Canterbury Regional Council for
resource consents to take and use
water from the Waimakariri and
Rakaia Rivers and for all associated
consents required for the
construction and operation of the
Central Plains Water Enhancement
Scheme

**RESPONSE TO OFFICERS' SUPPLEMENTARY REPORTS
AND SUBMITTERS' REPORTS
JULIAN JAMES WEIR**

Figure 1: Locations of selected calibration wells

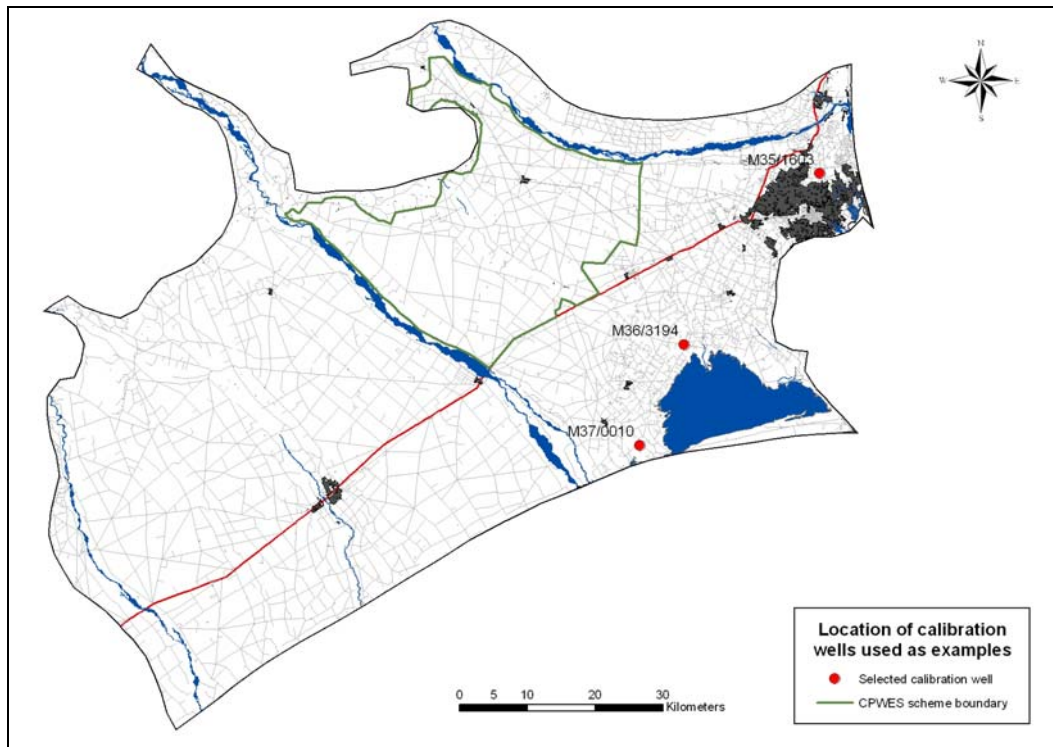
9. As a further example of this, I present additional examples of the comparison between measured and simulated groundwater levels for three calibration wells located in the lower plains area. The locations of these wells are shown in Figure 1 and the plots are reproduced from Aqualinc (2007) in Figure 2. There is good correlation between measured and simulated groundwater levels.

Figure 3: Groundwater level difference example

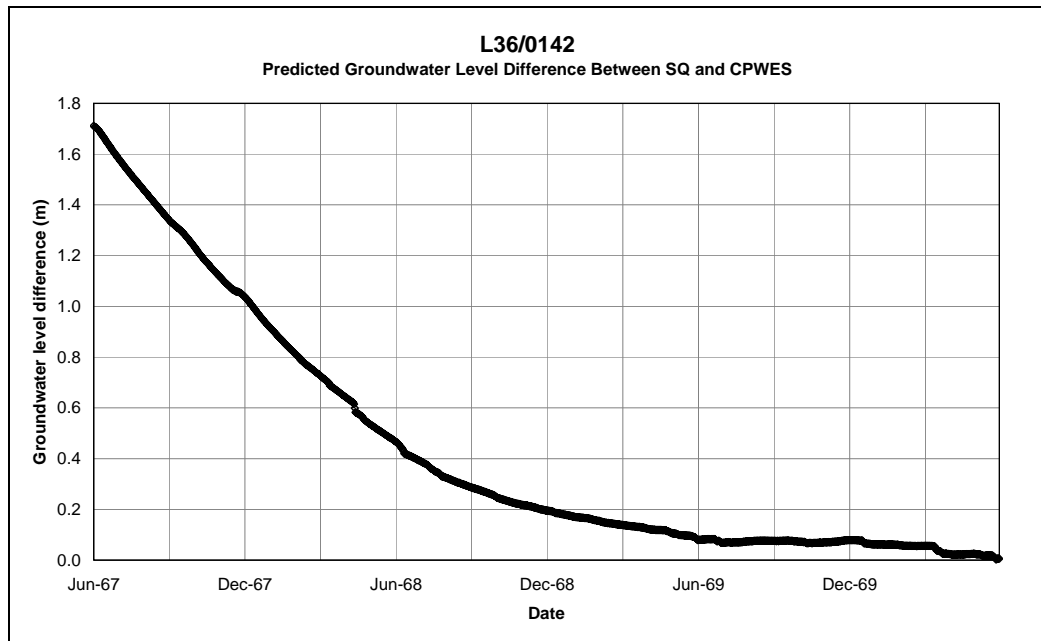
27. Para. 9 cont.: Based on his eigenmodel predictions, Mr. Scott has concluded that the new dynamic equilibrium could be reached in 6 to 8 years. Based on my assessment of Mr. Scott's Figure 2, the equilibrium is reached in about 4-6 years. Nevertheless, these predicted times are consistent with the predictions from the Canterbury groundwater model of 3 to 5 years (paragraphs 190-196 of my main evidence), that is a few years, rather than tens of years.

28. Further to this, most of the effects from the scheme are predicted to be realised within the first two years of operation (assuming full uptake and use of the water occurs when the scheme commences). In Figure 17 of my main evidence I presented plots showing two time series of transient groundwater levels under the CPWES scenario. One time series commences with the Status Quo groundwater levels and the other with CPWES groundwater levels. The convergence of these two lines describes how rapidly the effects from the CPWES are realised. To clarify this demonstration, I have plotted the difference between the two time series for one of the wells in Figure 17 of my main evidence, L36/0142, and this plot is presented in Figure 3.

29. Figure 3 shows how 90% of the effects from the scheme are realised within two years of commencement of the scheme, and the remainder shortly there after.

Figure 4: Measured groundwater levels in bore L36/0092

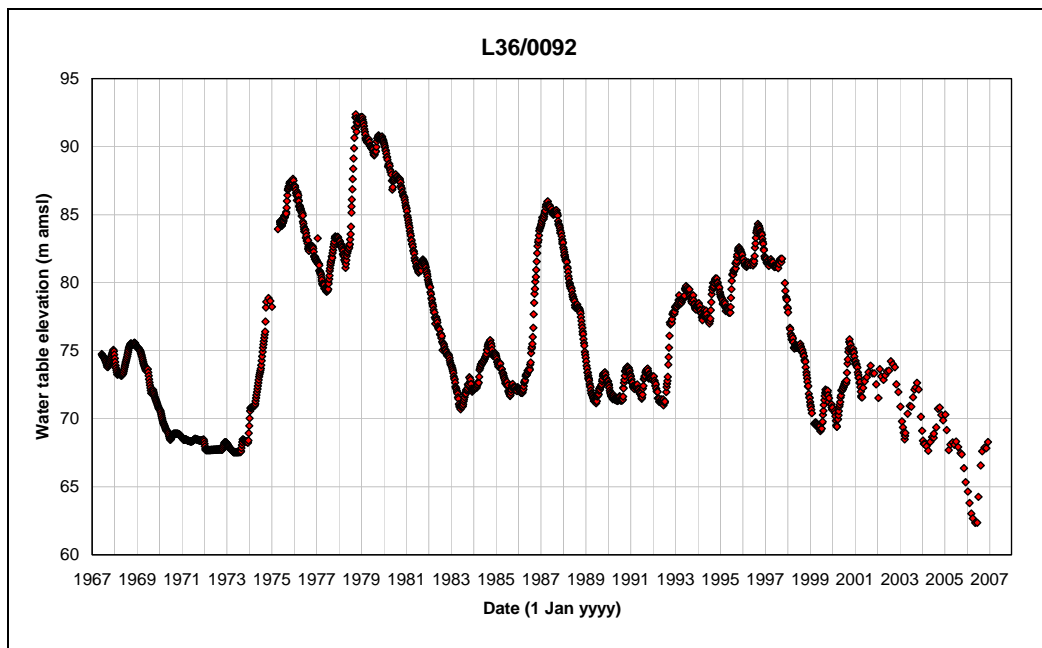
31. Related to this, and to Mr. Scott's suggestion in his paragraph 11 regarding a worst-case prediction, is that when groundwater levels are high (say due to extended periods of above average recharge), groundwater outflow is also high (head versus flow relationship). Consequently, high groundwater levels fall rapidly after the cessation of high recharge. As an example, the measured groundwater levels in bore L36/0092 (Figure 4) show rapid decline after relatively short periods of high levels.

32. The conclusion from this is that extended periods of high groundwater levels coinciding with extended periods of high irrigation demand do not exist. Periods of high irrigation demand occur when there is little rainfall, which corresponds to periods of low natural land surface recharge and naturally declining groundwater levels.

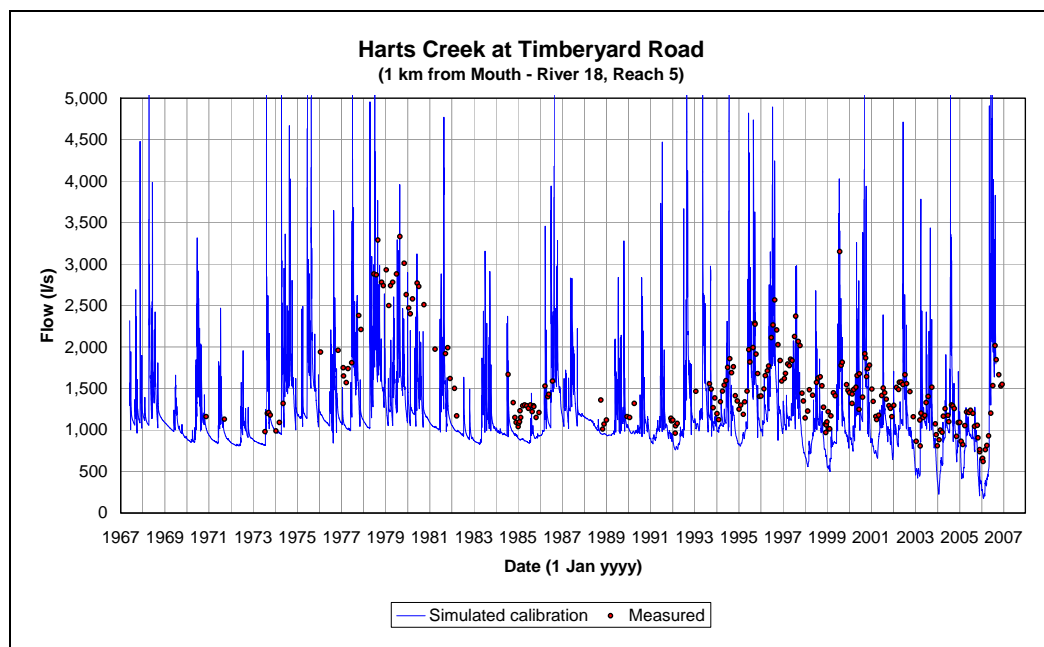
110. Para. 5.2: Much of the historical flooding in the lowland area can be attributed to high-intensity rainfall events rather than elevated groundwater levels. The photograph referred to in this paragraph is an example of this. If the drain was

working as intended (i.e. lowering groundwater levels by drainage), then the water level in the drain would be a measure of the adjacent groundwater levels. Adjacent groundwater cannot rise much higher than the water surface in the drain, because in doing so, it would discharge into the drain and groundwater levels would subsequently lower.

111. In the photograph, it appears that the drain's water surface is significantly lower than the water on the paddock, perhaps by up to a metre. Adjacent groundwater levels would therefore also be at a similar level (i.e. about 1 m lower than the adjacent land surface). It is therefore not likely that groundwater is causing the flooding. I would consider that the low infiltration rate through 'the finer silts and clays' (paragraph 5.4 of the Birkett's statement) would be the likely cause of the land surface ponding during high intensity rainfall events.
